# Technical Service Bulletin

## 40 Rumbling/creaking noises from front of vehicle while driving

40 18 84 2048266/4 August 9, 2018. Supersedes Technical Service Bulletin Group 40 number 18-83 dated July 30, 2018 for reasons listed below.

*Figure 1. Hydro-bushing.*

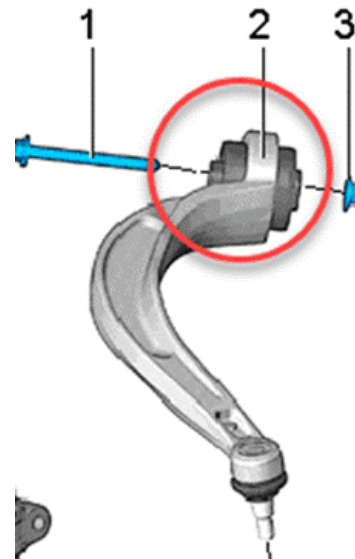
Modified hydro-bushing in control arm link (Figure 1):

- A6/A7 - 4G4HN011283 on 06/21/2016, part number 4G0407183B
- A8 - 4H7HN000731 on 06/01/2016, part number 4H0407183C
- Q7 - 4M2GD063812 on 04/29/2016, part number 4M0407183B

Check the lower guide link of the front axle as it may be the source of the noises. If necessary, replace the hydro-bushing on the guide link.
